# REPORT TO COUNCIL

**Application:** DP16-0124      **Owner:** Kane #3 Resources Ltd., Inc.  
No. BC1024155

**Address:** 1459 - 1469 KLO Road      **Applicant:** Highstreet Ventures Inc.

**Subject:** Development Permit

*Figure 1 - Contingency Plan: Alternate site access to be provided entirely within the Subject Property (1459 KLO Road).*

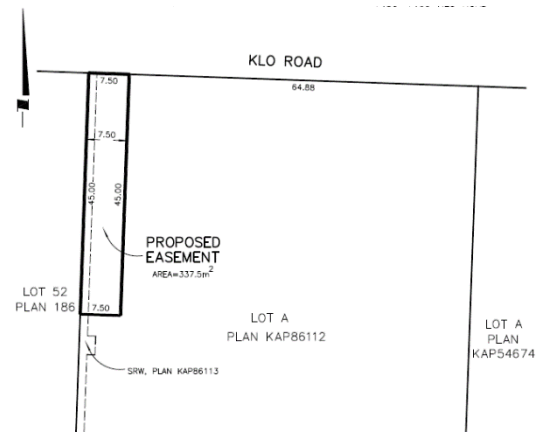
Currently, the applicant is working with the adjacent parcel owners to register a reciprocal cross-access agreement for the shared driveway. Should the adjacent development not proceed, the applicant is ensuring sufficient driveway access is provided within the subject parcel as indicated in *Figure 1*.
